Norfolk Boreas Offshore Wind Farm

A47 Substation Access Clarification Technical Note

Subject: Norfolk Vanguard, A47 Substation Access Clarification Technical Note

Figure 1. Location of Access A and D1 on the A47 at Necton

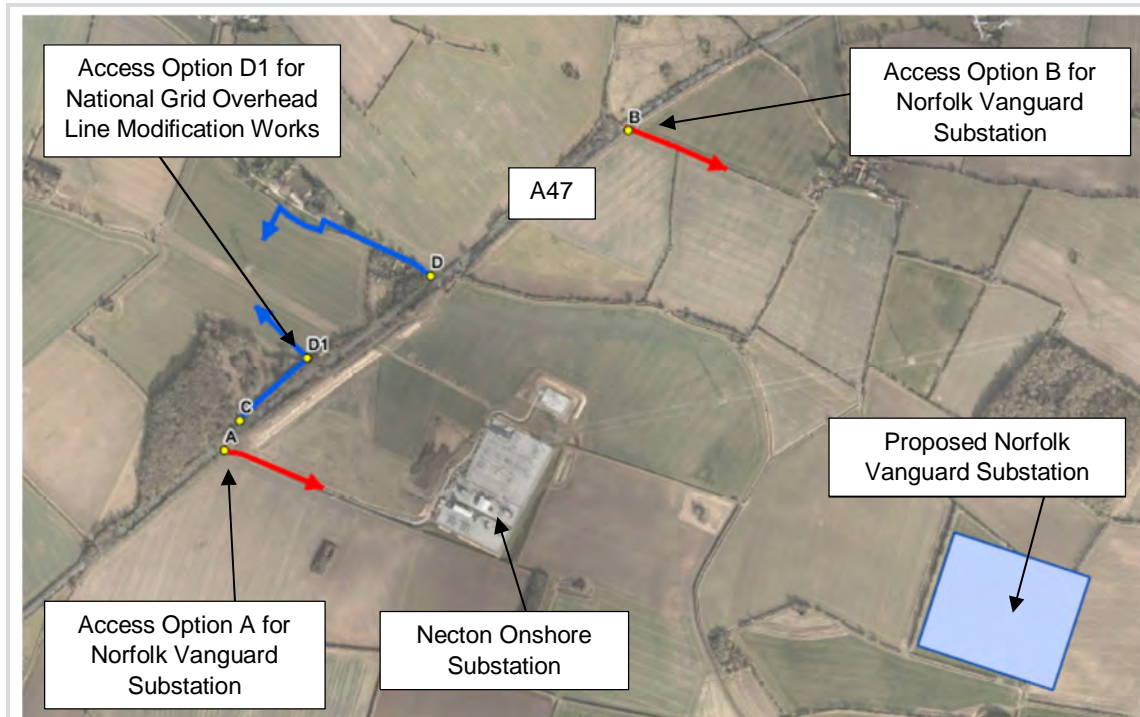
- 2.5. The location of the proposed accesses relative to each other and to existing junctions and accesses on the A47, is illustrated on Drawing PB4476-003-00X-002, an extract from which is reproduced as Figure 1 below.

A47 - SUBSTATION ACCESS A (AC181)
 SCALE - 1:250

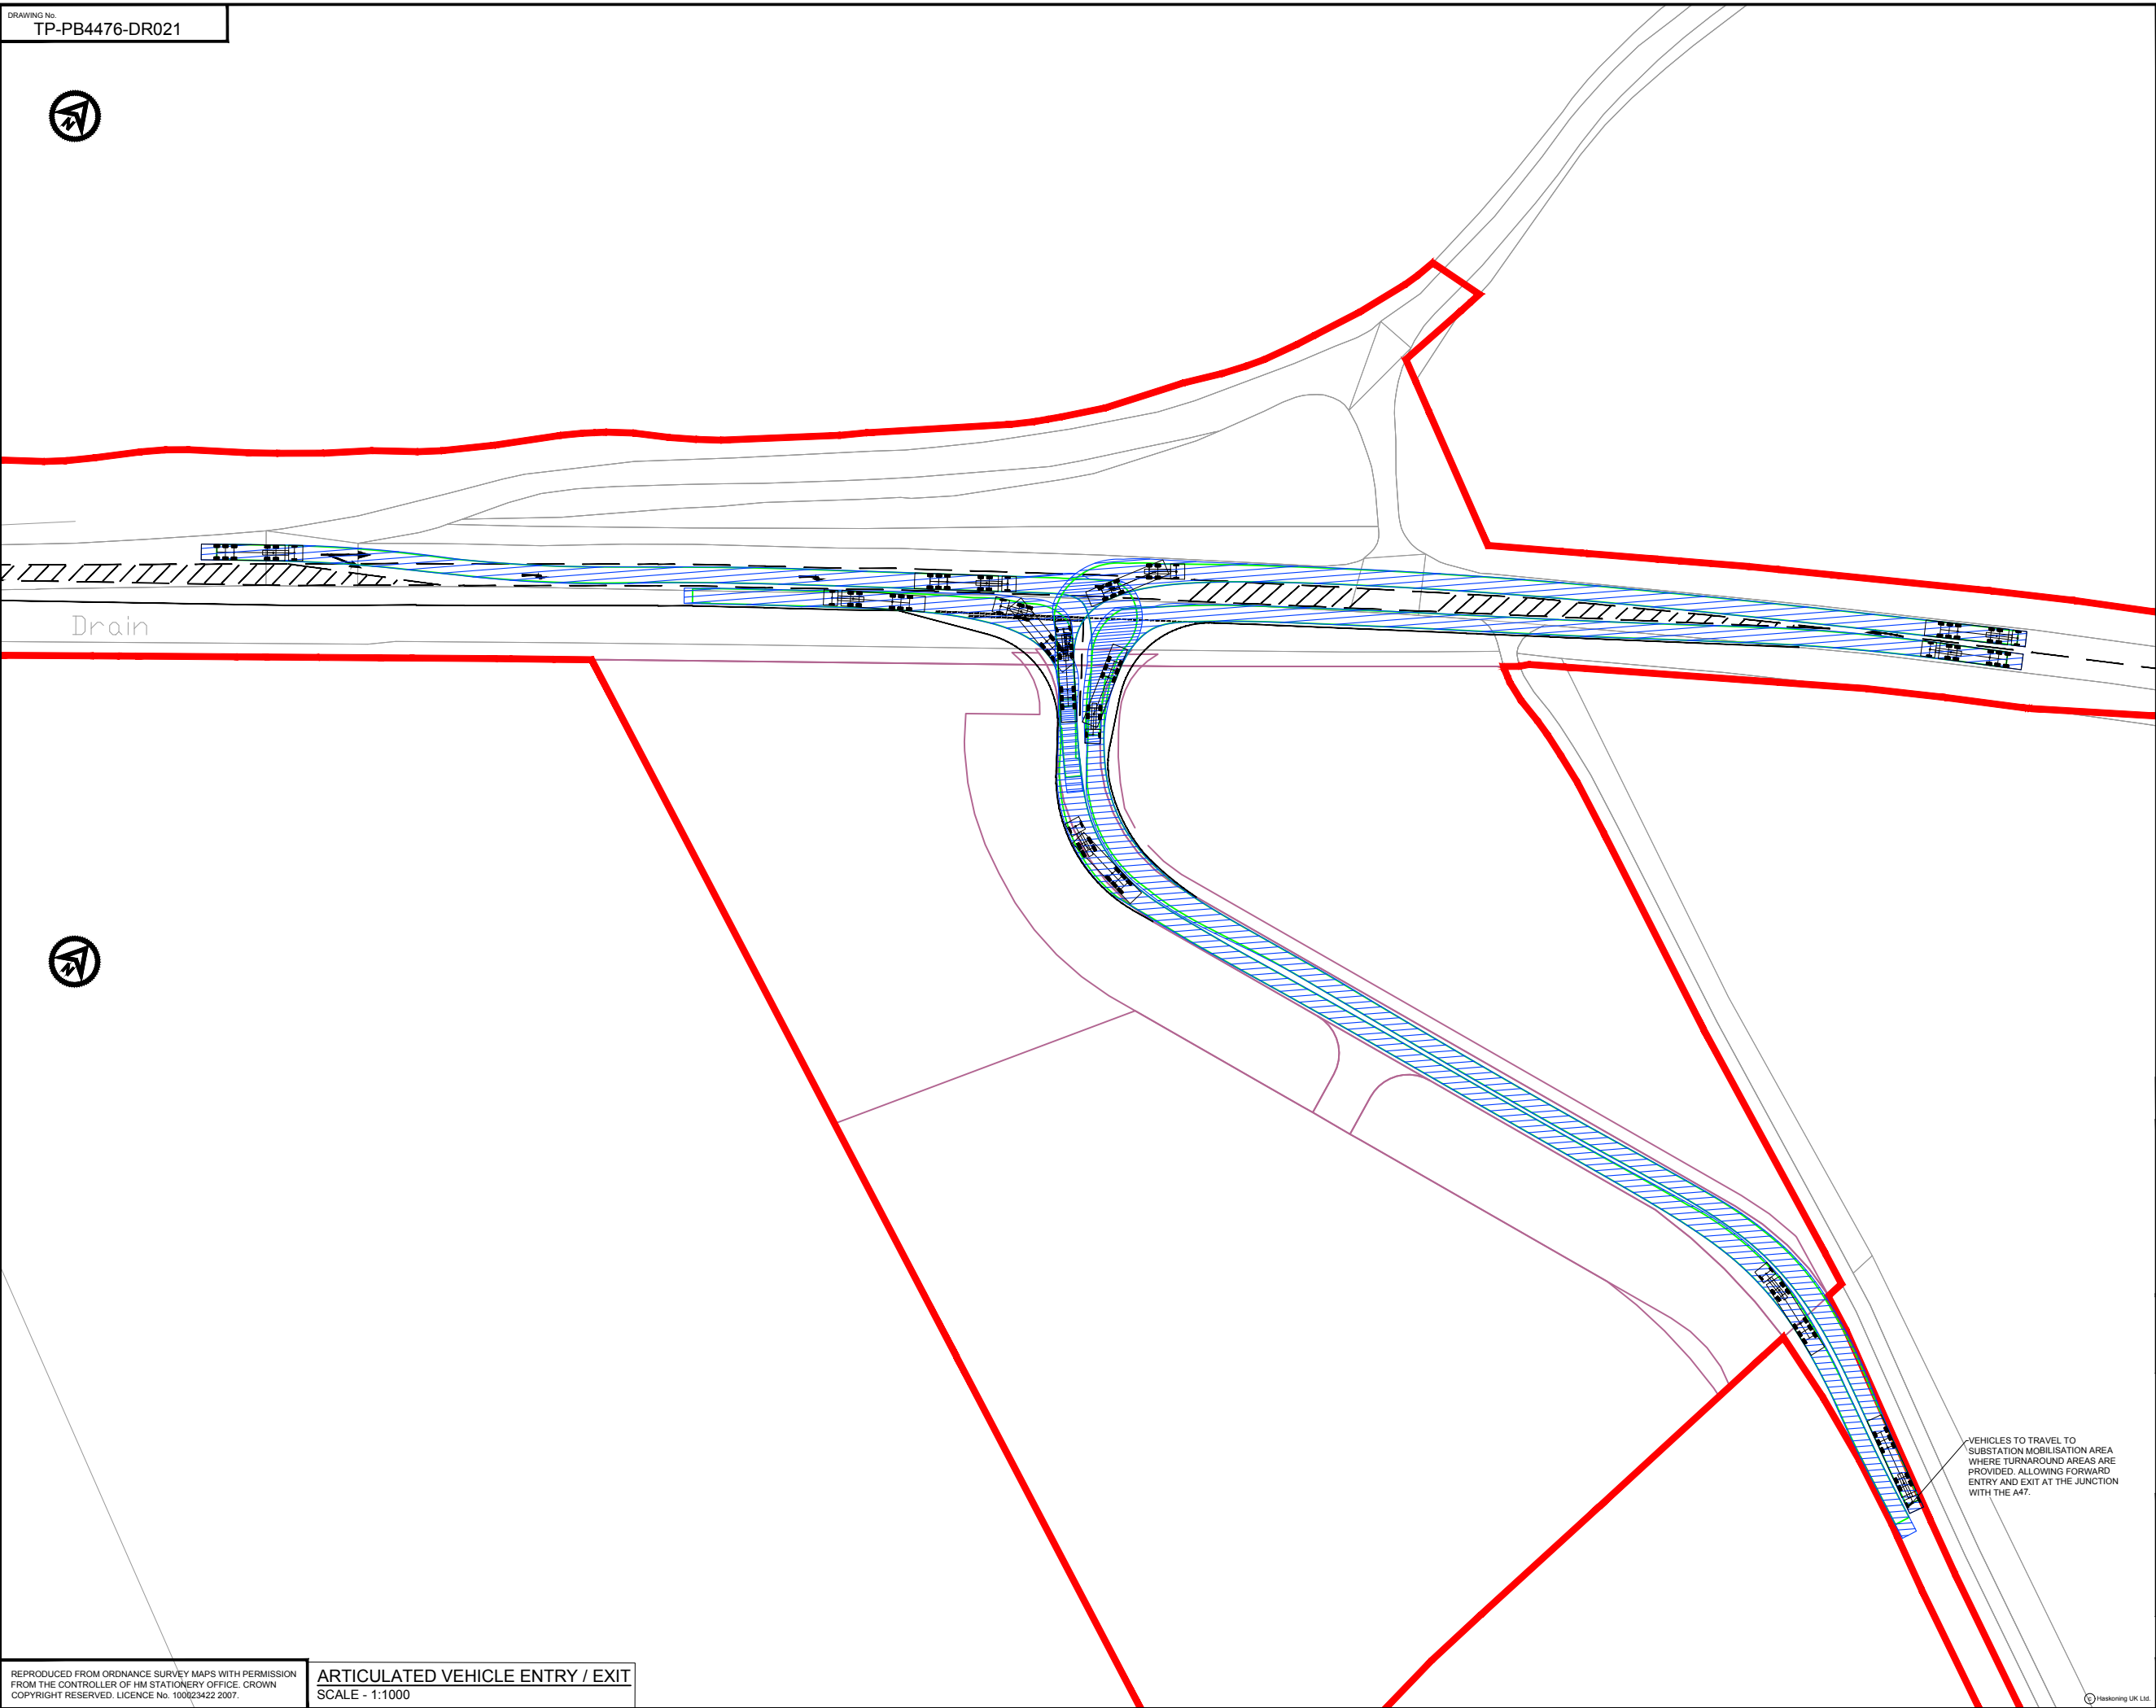
A revised access layout should be proposed that would allow vehicles to enter and exit at the same time on a fully paved surface. Vehicular swept path plots should be provided in support of the revised A47 Substation Access A junction layout to demonstrate the ability of an articulated vehicle and large tipper (the design vehicles) to negotiate all legitimate turning movements at the junction without overrunning kerb of A47 centre lines (Para. 4.11)	Critical	<p>A revised drawing TP-PB4476-DR012-F1.0 has been produced detailing the two-way movements of HGVs on a fully paved surface.</p> <p>Drawings TP-PB4476-DR017-F1.0 and TP-PB4476-DR018-F1.0 demonstrate the swept paths of the Design vehicles do not overrun the kerb or centre lines of the access road or the A47.</p>

Access	Doc.	Highways England Recommendation	Critical / Important	Norfolk Vanguard Design Response
		The proposed corner radii and exit tapers at Access A should be reviewed in the context of the guidance set out in TD 42 and the grasscrete over-run area extended if necessary to provide the appropriate corner radii and tapers (para. 4.15)	Critical	Drawing TP-PB4476-DR012-F1.0 details the junction revised to incorporate a DMRB compliant rural simple junction including 15m radii with tapers of 1:10 over a distance of 25m.
Access D1 (AC 182)	BN06	A fully compliant DMRB arrangement comprising a ghost-island right turn would represent the preferable junction arrangement at this location (para. 5.2)	Important	<p>A ghost-island junction would be a disproportional solution in context of the traffic demand set out in Table 4.2.</p> <p>A commitment will be included within an update to the OTMP for an upgraded DMRB compliant simple rural junction with a 'no right turn' traffic management access strategy. To be enforced via the measures presented within the OTMP.</p>

- 4.8. The proposed access illustrated by drawing no. TP-PB4476-DR012 Rev D0.3 appears to retain the existing priority T-junction with the A47 in situ. Whilst the RHDHV assertion that vehicular right-turn movements will be removed and controlled by an Access Management Strategy is noted, **AECOM consider that, in principle, a fully compliant DMRB arrangement comprising a ghost-island right-turn would represent the preferable junction arrangement at this location.** Any subsequent proposals for a DMRB compliant ghost-island right-turn arrangement would need to consider the implications for the access to 'The Grove' located almost opposite (see paragraph 4.13 below).

- 4.14. Drawing TP-PB4476-DR012 Rev D0.3 illustrates the extent of land required to be clear to provide visibility splays of 4.5m x 215m in each direction from the centre line on the minor road. AECOM are satisfied that a Desirable Minimum Stopping Sight Distance (DMSSD) of 215m is appropriate in this location and is consistent, in principle, with the requirements of TD 9 (Table 3) with respect to forward visibility for the major road right-turn (notwithstanding the proposed Access Management Strategy left-in / left-out operation) and TD 42 (Table 7/1) with respect to 'y' distance from the Minor Road. AECOM are also satisfied that an 'x' distance of 4.5m is appropriate and consistent with the acceptable relaxation in difficult circumstances set out by TD 42 (para. 7.8) for lightly trafficked simple junctions. AECOM note the presence of a significant number of mature trees in the hedgerow on the south side of the A47 on both sides of the access point and that these trees also serve the function of screening 'The Grove' from views of the substation. It is unclear from the drawing provided how much of the hedgerow and how many of the trees would have to be removed in order to achieve the visibility splays shown. Notwithstanding this, AECOM are satisfied that a DMSSD visibility splay of 4.5m x 215m is likely to be achievable in both directions from the minor road, in the horizontal plane, subject to the clearance of vegetation from the identified area. Para 3.1 of the OAMP acknowledges the presence of a crest curve located approximately 200m north east of the access point. **AECOM recommend that visibility splays of 4.5m x 215m from Access A in accordance with the requirements of TD 42 are demonstrated to be deliverable in both the horizontal and vertical plane within land in the control of either the applicant or the highway authority at the detailed design stage.**

- 4.15. Drawing TP-PB4476-DR012 Rev D0.3 illustrates entry/exit corner radii of 6m and 10m respectively on the minor road at Access A whilst the existing provision of 'grasscrete' over-run areas adjacent to the service road delivers effective entry/exit corner radii of 12m and 14.5m respectively. AECOM consider that the proposed corner radii fall short of the provision recommended by TD 42 (para. 7.17) which advises that "Where provision is to be made for large goods vehicles, the recommended circular corner radius is:- b. 15m at rural simple junctions, with tapers of 1:10 over a distance of 25m". The standard requires an exit taper into both the major and minor road arms, however an approach taper from the major road is not required. The layout illustrated on drawing TP-PB4476-DR012 Rev D0.3, does not provide for an exit taper into the minor arm or into the major road. AECOM consider that this is likely to be contributory in the over running of centre lines on the A47 shown on the swept paths referred to above. **AECOM recommend that the proposed corner radii and exit tapers at Access A are reviewed in the context of the guidance set out in TD 42 (para. 7.17) and the paved area extended if necessary to provide the appropriate corner radii and tapers.**
